ERA Architects Inc.  
10 St. Mary Street, Suite 801  
Toronto, Canada  
M4Y 1P9

**Re: 100 Simcoe Street, Inclusion on the City of Toronto's Heritage Register - Item No. PB20.2**

We have prepared this letter and the accompanying annotated photographs in response to the recommendation that City Council include 100 Simcoe Street on the City of Toronto's Heritage Register.

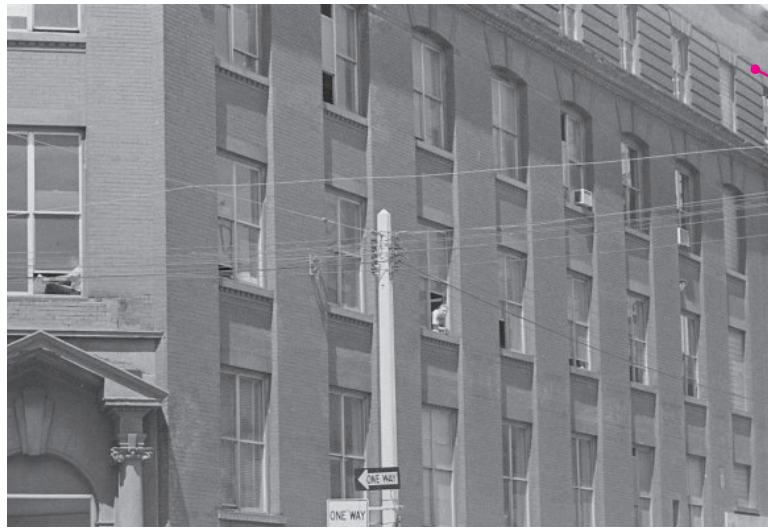
cupola removed

cornice removed

string course removed

banded rusticated brickwork removed

fenestration altered

cut stone door surround removed
